Memorandum for: Portland District Regulatory Branch, Ms. Debra Henry

Subject: Project Review Group (PRG) Technical Memorandum for the Sampling and Analysis Plan (SAP) for NWP-2007-195, Vigor Industrial berth deepening.

Prepared by: James M. McMillan (CENWP-OD-G)

Figure 2. Dry Dock 1.

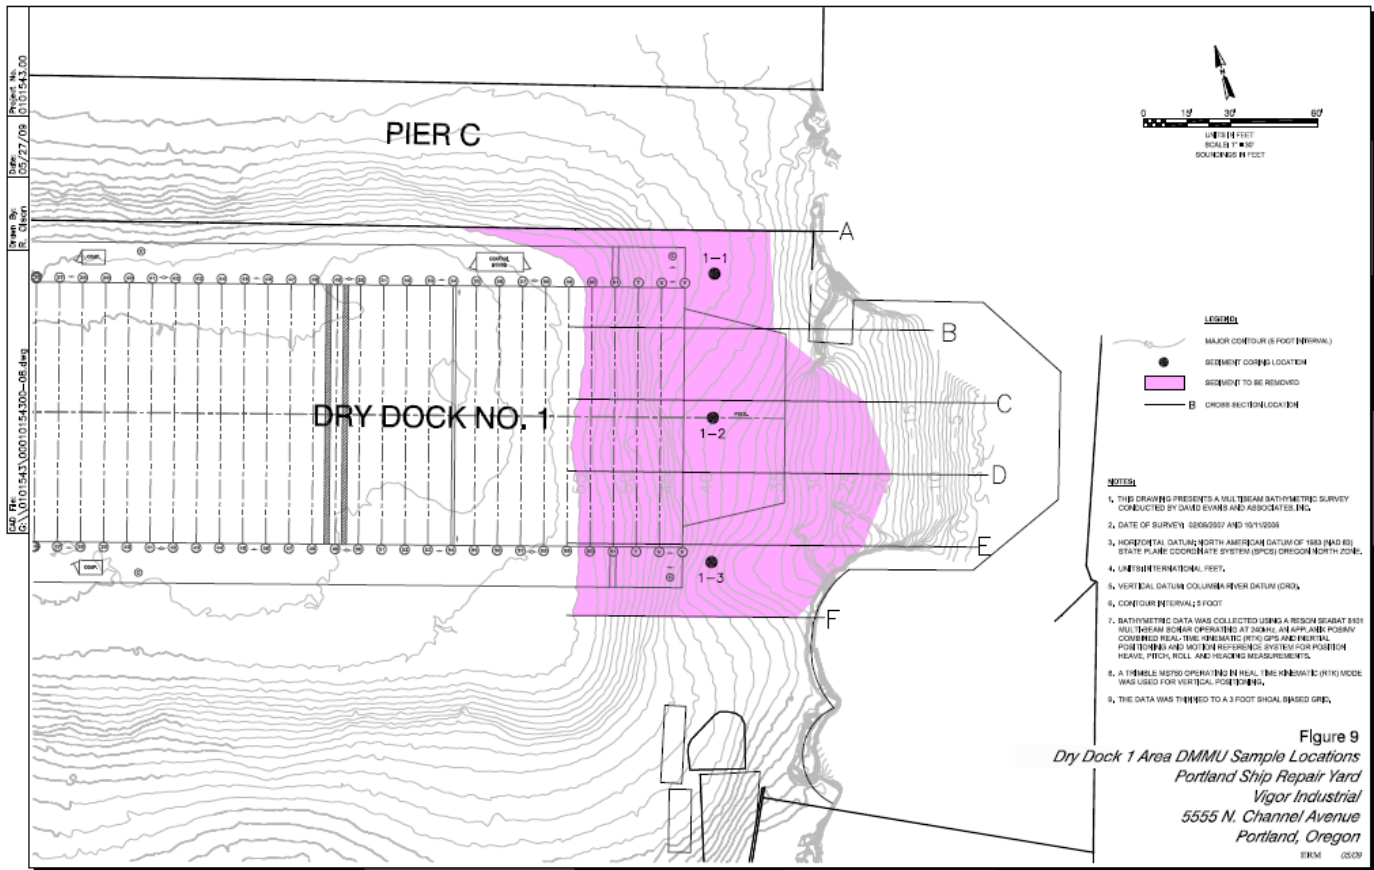
Dry Dock 1: The proposed the Dry Dock 1 Area consists of Section 1 and is comprised of a single DMMU, identified as DMMU 1 (Figure 2).

A total of 3 cores would be taken from Dry Dock 1. In Section 1, sample cores will be collected from three locations (1-1, 1-2, and 1-3) in 5-foot increments, to a maximum depth of 20 feet. The material from 0 to 15 feet below mudline (i.e. the maximum dredge depth) in each core will be composited into a single sample and submitted for chemical and physical analysis. The three samples of the new surface material (NSM) from 15 to 20 feet below mudline will be archived discretely for future analysis, pending the results of the composite sample analysis.

Dry Dock 1: No alternatives proposed.

Figure 3. Dry Dock 3.

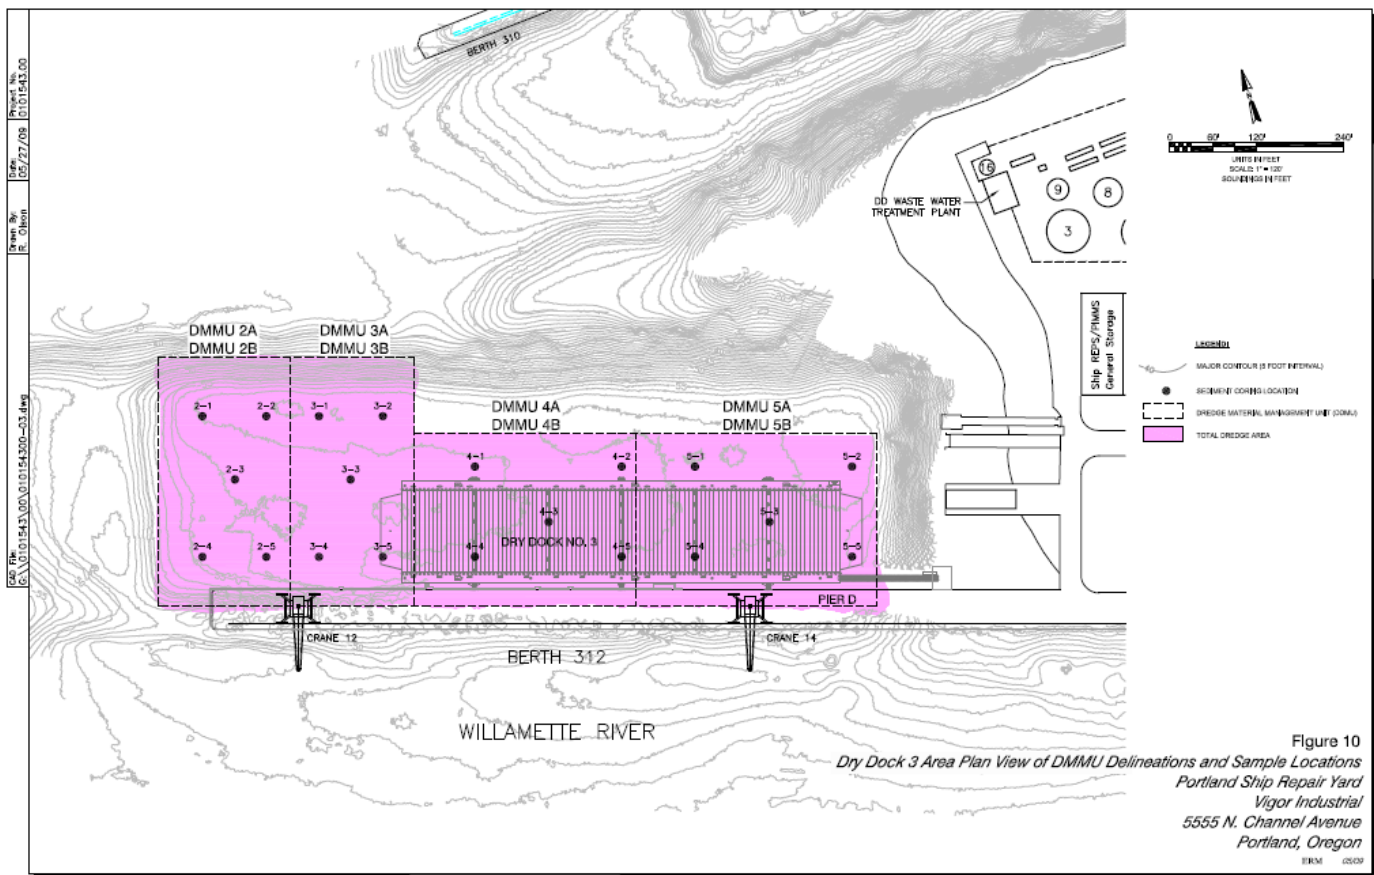
each coring location (i.e., one sample from each of the two DMMU layers and one of the newly exposed surface material in each location). The specific coring locations within the footprint of Dry Dock 3 are based on the 5-foot wide spacing between the six flotation tanks (98-foot centers). Samples from the equivalent depths within the same DMMU will be composited and submitted for chemical and physical analysis. The 25 samples (one from each coring location) of NSM will be archived discretely, pending the results of the composite sample analysis. Sampling locations for Dry Dock 3 appear in Figure 3 (Vigor's Figure 10) (attached)

Commented [D1]: They need to analyze at least 12 of these samples discretely.

1. Vigor Industrial's SAP for their dry dock maintenance dredging does not meet the SEF guidance as proposed. At least 12 of the NSM samples need to be discretely characterized to gauge if the project will improve or degrade the aquatic environment (as compared with the existing surface). Additionally, the NSM thickness should bracket the target dredge depth (-65' CRD), and should be 3 feet thick.

Figure 4. PRG Optional Sampling configuration. The orange points are the proposed alternative vibracore sampling locations.

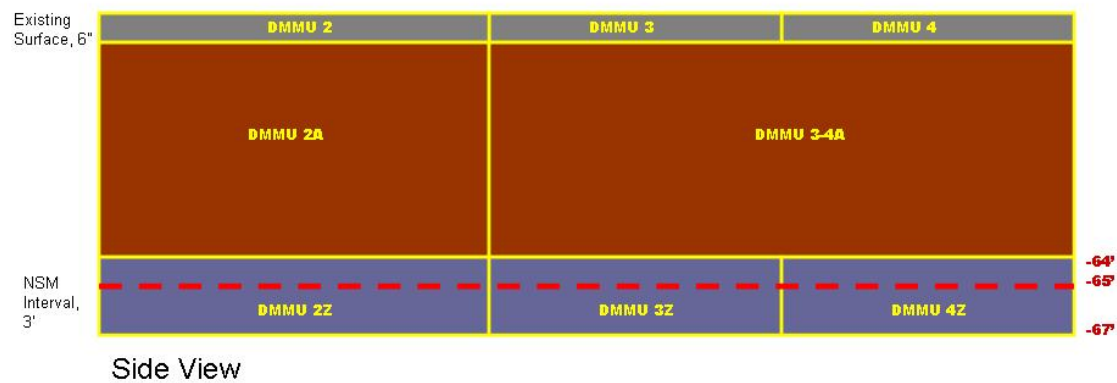
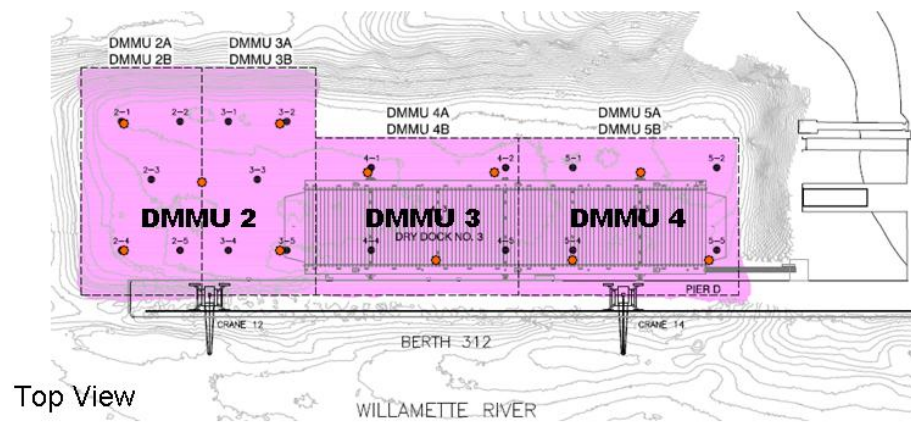
Refer to Figure 4 attached at the end of this memo. The PRG proposes the following alternative sampling scheme to meet the sampling objectives:

- Total volume characterized at high-rank requirements: ~38,000 cy
- 8 DMMUs (3 levels); 5 cores in DMMU 2, and 3 cores each in DMMUs 3 and 4 (11 cores)
- Discrete analyses for the NSM samples (11 discrete analyses)
- Composite analyses for the existing surface layer (3 discrete analyses)
- Composite material from DMMU 2A into one sample; composite material from DMMU 3-4A into one sample; 2 composite sample analyses total
- Total analyses: 16

Commented [Isi6]: Existing surface layer is being characterized in DMMU 2-4, with top 6 inches of material composited for each DMMU, right? If so, need to add a bullet. This leaves the bottom of the 11 cores for NSM analysis (discrete) (can't get an even 12 out this plan, hope there is not a reason Dan wants 12).

Commented [D7]: Since there are only 4 DMMUs overlying the NSM, 12 discrete analyses are probably necessary.

Commented [D8]: What about compositing each dredge prism DMMU for a total of 8 dredge prism samples?

5. Vigor has the option to utilize the PRG's sampling scheme, which would reduce the total number of cores and DMMUs over the project.

Additionally, the PRG recommends that all 11 NSM intervals are archived (discretely) in the event that biological testing is warranted.
